MEMORANDUM

RE: Rock Creek Club (2325 Porter Street NW)
BZA – Case #21510
Response to Symmetra Design's Memoranda dated October 5, 14, and 26, 2026

DATE: October 30, 2026

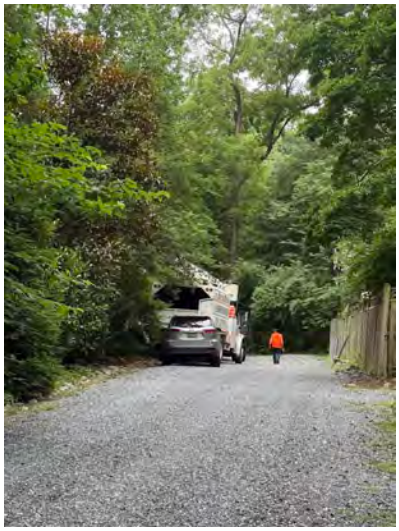
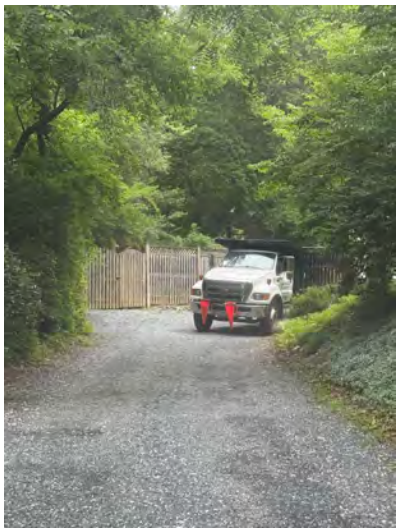
- New 10/24/26 Comment: The study does not evaluate pedestrian safety along the shared gravel road, which also serves as the pedestrian access route for existing residences. The gravel road accommodates both vehicular and pedestrian activity and provides the only pedestrian access to the residences along it. With an existing traveled way generally

approximately 14 to 16 feet wide and no separate pedestrian facility, residents walking along the road would share the available roadway space with Club-related vehicles, including pickup/drop-off, employee, vendor, and delivery/service traffic. The Transportation Statement does not evaluate how pedestrians and vehicles would safely navigate constrained sections of the road, particularly when opposing vehicles meet or when vehicles are required to wait, pass, or back up. The adequacy of the shared roadway to accommodate both pedestrian and vehicular movements under the proposed operating conditions has not been demonstrated.

W+A Response: The gravel road already operates as a shared space. Residents currently walk along it alongside residential, visitor, delivery, and service vehicles, with no separate pedestrian facility. The RCC would not introduce a new type of interaction; it would add a small number of vehicles to an existing shared environment. As described in the response above, the road has many of the characteristics of an intentionally designed shared street: it is narrow, has a textured gravel surface, carries low traffic volumes, and has no curbs or separate sidewalks. Each of these features keeps vehicle speeds low. At low speeds, drivers can see and react to pedestrians in time, can stop within a short distance, and can readily slow down or pull over to let pedestrians pass.

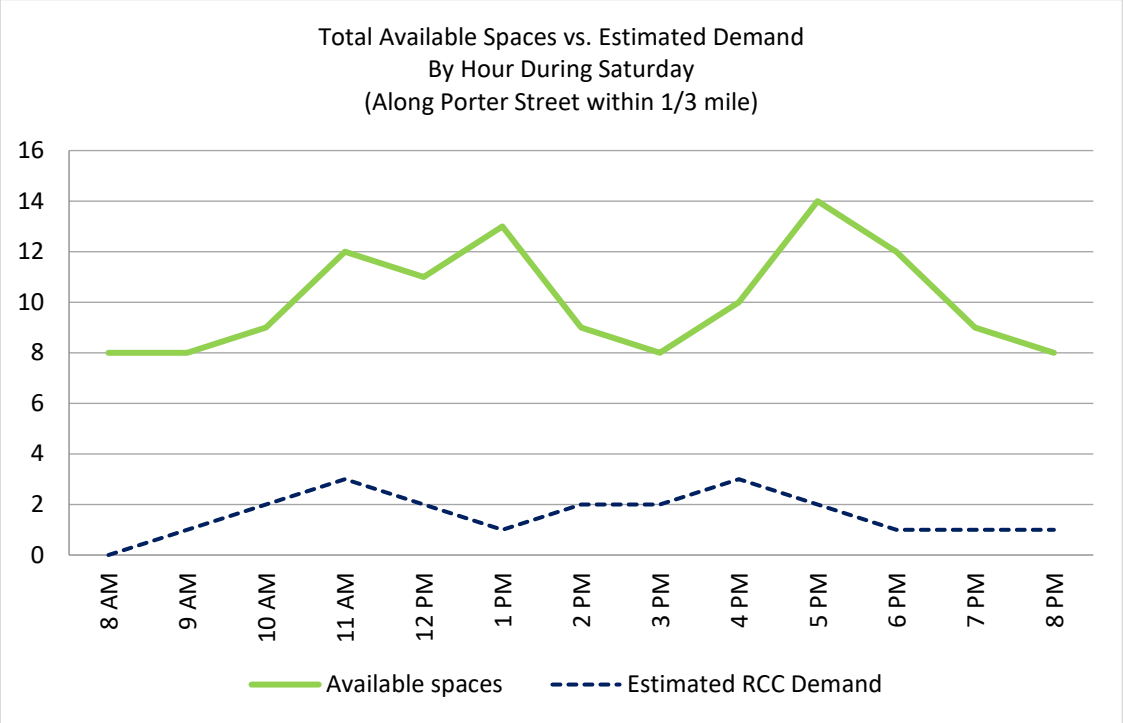
- **The study does not calculate how many Club vehicles would be parked at the same time.** The Transportation Statement provides vehicle-trip estimates but no corresponding parking-demand or accumulation analysis accounting for arrivals, departures, and length of stay. Existing availability of approximately 10–19 on-street spaces during the weekday observations does not establish that Club parking demand can be accommodated. Demand associated with overlapping programming, small events, and special events is not separately established.

Weekday on-street parking counts conducted on September 1st revealed that parking availability within ⅓ mile of the site ranged from 10 spaces to 19 spaces through the 6:00 PM sweep. Looking at the extent of parking along Porter Street between the site and Connecticut Avenue shows that 23 to 37 spaces were available through the 6:00 PM sweep. Therefore, on-street parking is expected to accommodate the anticipated typical weekday parking demand for the RCC.

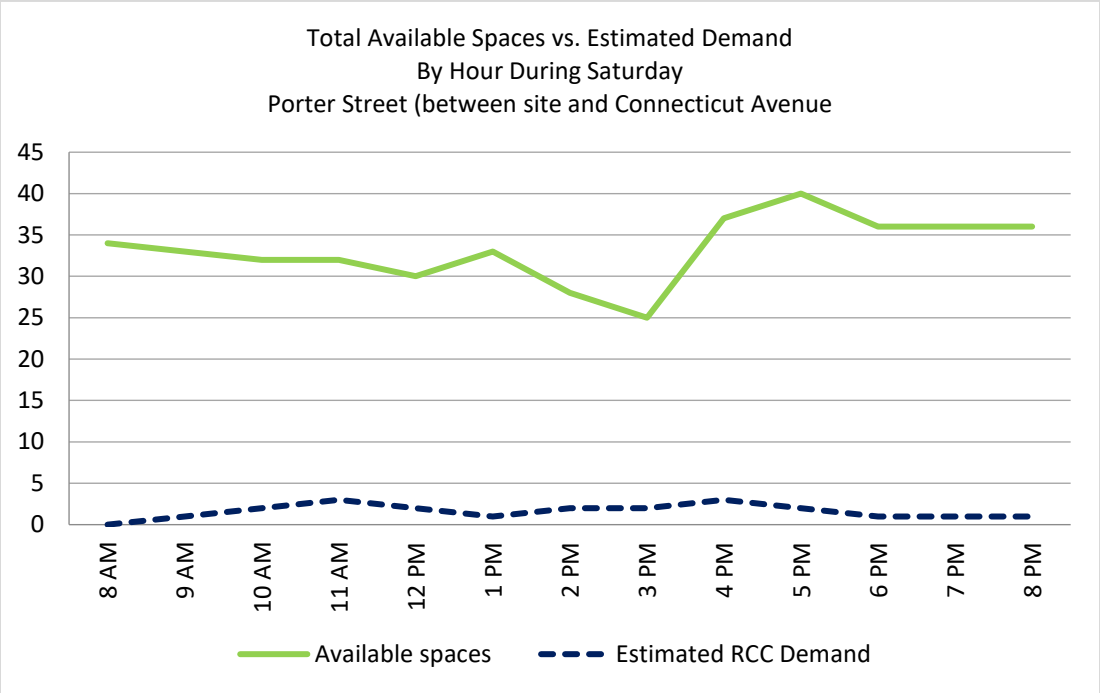
- **Saturday observations identify periods when little or no on-street parking is available.** Approximately 42 of the 43 identified spaces were occupied at 1:00 PM on Saturday. The Transportation Statement attributes the elevated demand to nearby religious services and identifies greater availability later in the day. However, the observation demonstrates that concurrent neighborhood activity can substantially reduce available parking and does not establish how Club parking demand would be accommodated under those conditions.

As shown below, the available parking on Porter Street within 1/3 mile of the site ranges from eight to 14 spaces throughout the day, which is expected to adequately accommodate anticipated parking from the RCC on a typical Saturday. Importantly, the data shows that eight spaces remain available between the 8:00 and 9:00 PM hour.

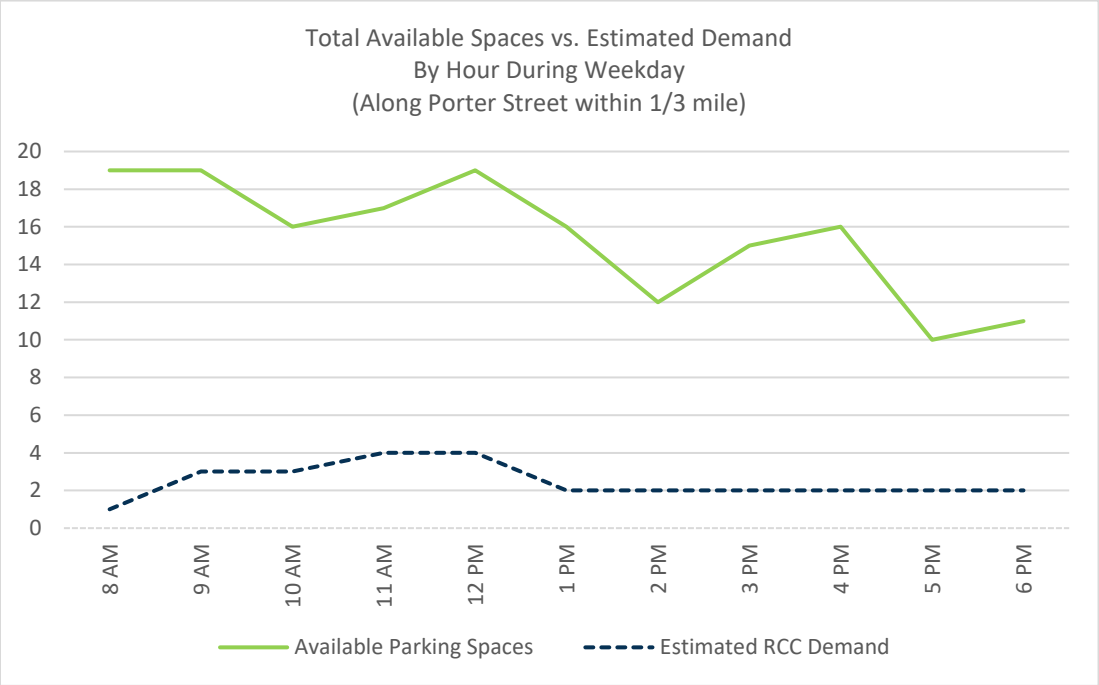
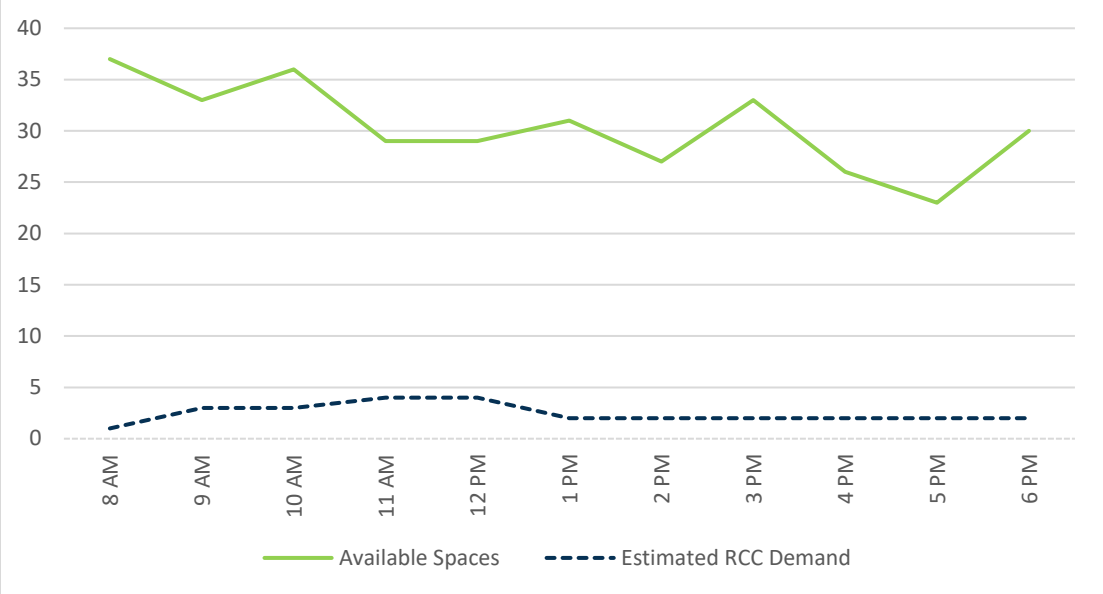
- **The parking surveys do not adequately capture evening parking conditions.** The weekday survey ends at 6:00 PM, while the Club would remain open until 9:00 or 10:00 PM. DDOT's May 2024 CTR Guidelines identify 6:00–10:00 PM as the typical weekday evening peak-demand period for residential uses. Because the surrounding neighborhood is residential, the survey ends just as this typical evening peak-demand period begins and therefore does not establish parking availability during the period when residential and Club parking demand may overlap.

W+A Response: The last parking sweep for the on-street parking occupancy study was conducted between 6:00 and 7:00 PM for the weekday counts. The parking survey period was chosen to match RCC's peak operating periods when its activity, and therefore parking demand, would be the highest. The purpose of the survey was to determine whether on-street parking would be available when RCC generates the most parking demand, which would occur midday. RCC activity after 7:00 PM is expected to be substantially lower.

Based on the accumulation of hourly weekday trips, in the hours after 7:00 PM, a maximum of one to two vehicles could be expected to park on the street. As shown below, the available parking on Porter Street within 1/3 mile of the site is expected to adequately accommodate anticipated parking from the RCC throughout the weekday.

When expanded to the length of Porter Street between the site and Connecticut Avenue, even more parking is available, as shown below.
